**RESPONSES TO THE TOWN OF NORTHBOROUGH PLANNING REVIEW COMMENTS
DATED APRIL 10, 2024**

**RESPONSES TO THE TOWN OF NORTHBOROUGH SITE PLAN REVIEW COMMENTS
DATED APRIL 11, 2024**

**NORTHBOROUGH
 FIRE STATION
 NORTHBOROUGH, MA**

PROJECT NO.: 23141.00
 DATE: MAY 14, 2024
 SCALE: 1"=20'
 DESIGNED BY:
 CHECKED BY: AKL
 DRAWN BY:
 APPROVED BY:
 DRAWING TITLE:
GRADING PLAN
 DRAWING NO.:
C4.0
 SHEET NO. 7 OF

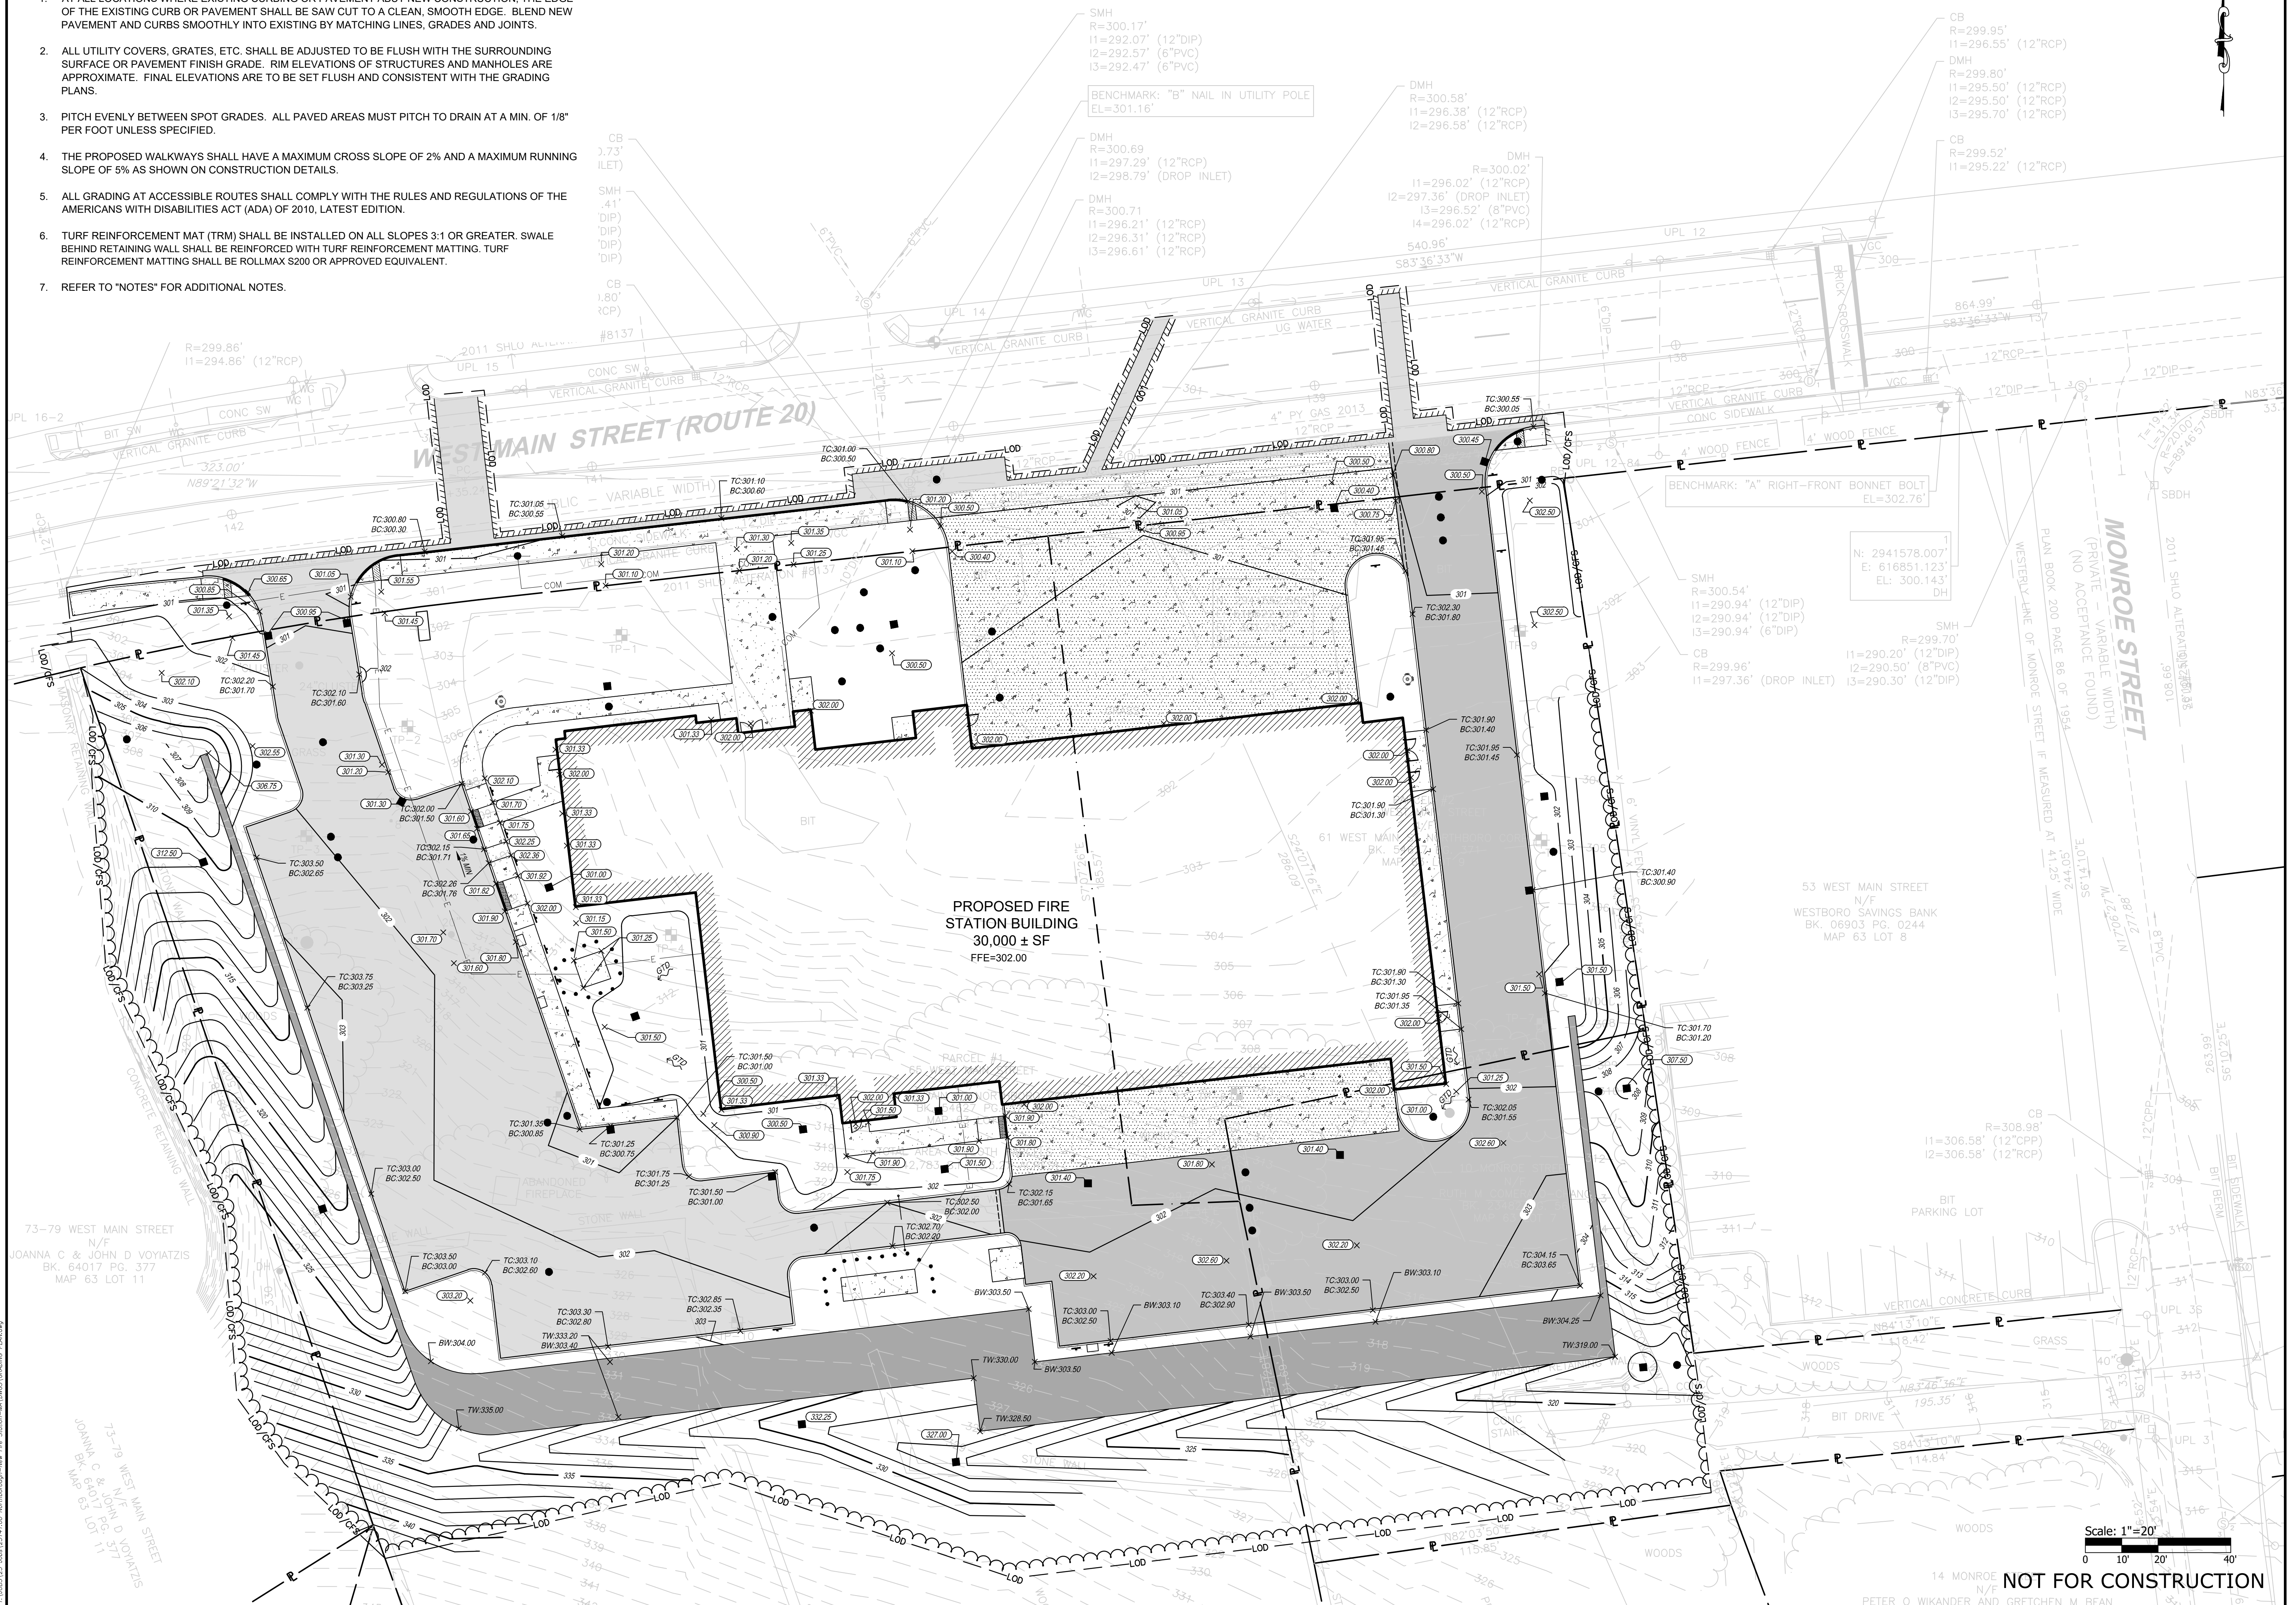
9. **COMMENT:** It is unclear if the sidewalk proposed along the east side of the building has a 7" high safety curb at the building egress location per Zoning Bylaw Section 7-09-030E(4). A detail of the curb should be added to demonstrate compliance with this requirement, or the Applicant should submit a written waiver request for Planning Board consideration.

RESPONSE: *Sheet C-400 Grading Plan has been revised to provide a 7" curb reveal.*
